HISTORIC AND DESIGN REVIEW COMMISSION

June 05, 2019

HDRC CASE NO: 2019-303
ADDRESS: 306 CALLAGHAN AVE
LEGAL DESCRIPTION: NCB 721 BLK 3 LOT N 80.04FT OF 2
ZONING: RM-4, H
CITY COUNCIL DIST.: 1
DISTRICT: Lavaca Historic District
APPLICANT: Frederic Wile/WILE FREDERIC D
OWNER: Frederic Wile/WILE FREDERIC D
TYPE OF WORK: Construction of a rear accessory structure
APPLICATION RECEIVED: May 18, 2019
60-DAY REVIEW: July 17, 2019
CASE MANAGER: Huy Pham
REQUEST:

The applicant is requesting a Certificate of Appropriateness for approval to construct a rear accessory structure to feature approximately one-hundred forty (140) square feet and materials to match the primary historic structure.

Wile Backyard shed
West Elevation
306 Callaghan Ave

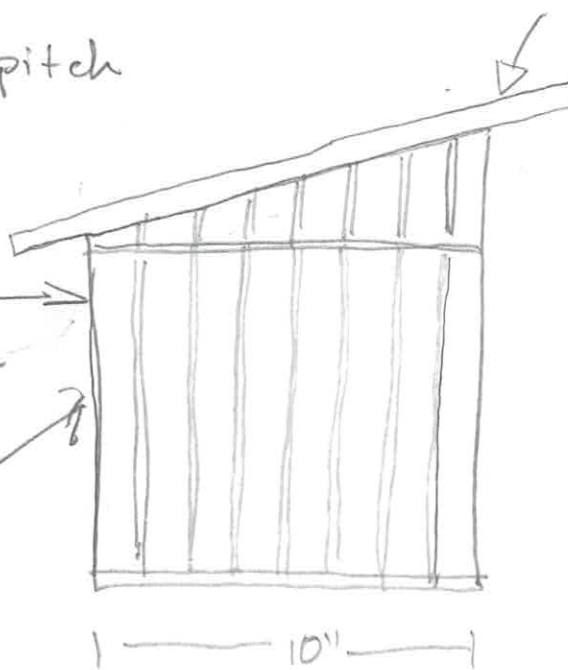
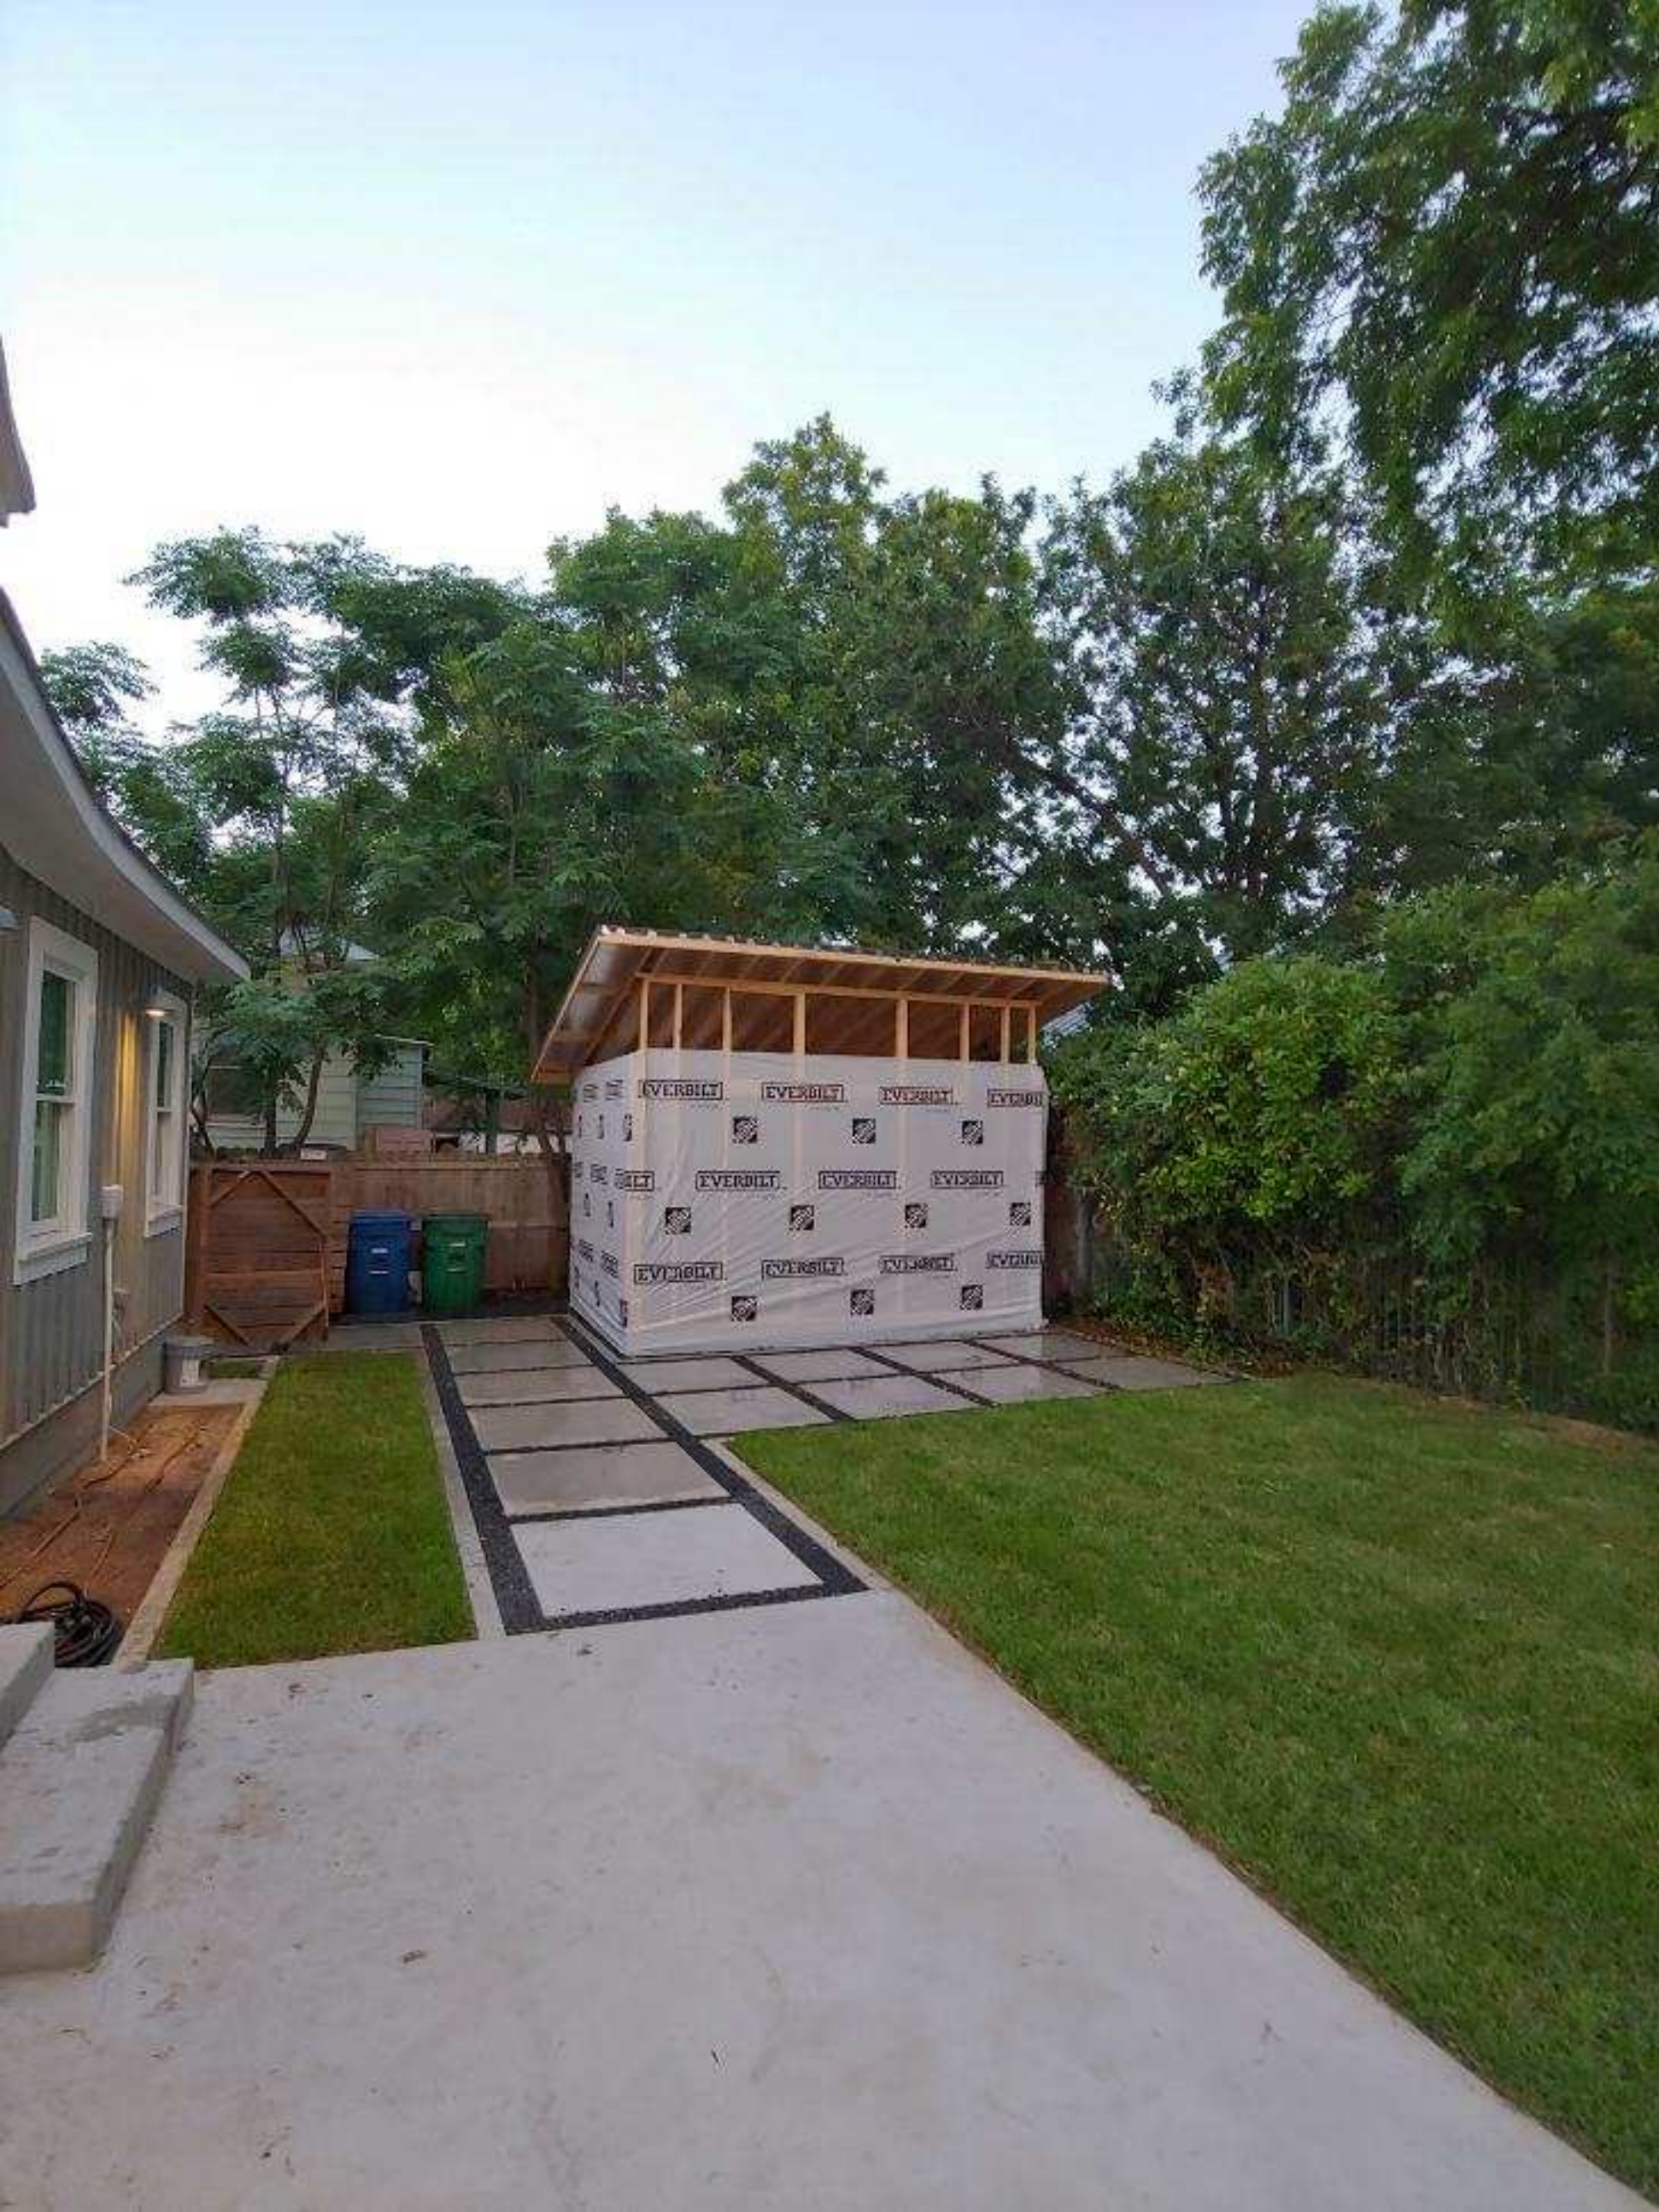
- c. **MASSING, FORM, AND SIZE** – The applicant has proposed to install a rear accessory structure featuring ten-feet (10') in width, fourteen-feet (14') in length, and up to eleven-feet five-inches (11' - 5") in height. The accessory structure features a simple shed form, with the roof sloping upward facing into the rear yard. Consistent the Guidelines for New Construction 5.A.i. and ii., staff finds that the proposed structure is visually subordinate to the principal historic structure in height, massing, and form, and is no larger than 40 percent principal structure's footprint.

- d. **CHARACTER AND DESIGN** – The proposed rear accessory structure features board-and-batten siding, and a standing-seam metal shed roof. Staff finds these features generally relate to the principal historic structure and is consistent with the Guidelines for New Construction 5.A.iii.

- e. **DOORS AND WINDOWS** – The proposed rear accessory structure features three (3) facades featuring no fenestration details while the yard-facing façade features a six-lite, tempered glass configuration with a centered door. Per the Guidelines for New Construction 5.A.iv. notes that window and door openings should be similar to those found on historic garages or outbuildings in the district or on the principle historic structure in terms of their spacing and proportions. While the full-glazing elevation design is not found on historic outbuildings within the district, staff finds that this elevation faces into the yard and is minimally visible from the public right-of-way. Staff finds that the proposed fenestration details are appropriate considering the scale and orientation of the accessory structure.

- f. **ORIENTATION AND SETBACK** – The proposed rear accessory structure is set in the rear corner of the property, at the end of the driveway. The structure is set twenty-seven inches (27”) from the neighboring property line (fence) and twenty-four inches (24”) from the rear property line. Consistent with the Guidelines for New Construction 5.B.i and ii., staff finds that the structure matches the orientation of similar outbuildings on the block and generally follows the historic setback pattern of the block, which features narrow rear yards where accessory structure are closer to property lines. In this instance, historic setbacks are not consistent with UDC requirements and a variance may be required.

Staff recommends approval of the rear accessory structure based on findings c through f. The applicant is responsible for complying with all setback requirements as required by the UDC and Development Services Department, Zoning Division, and for obtaining a variance from the Board of Adjustment, if applicable.
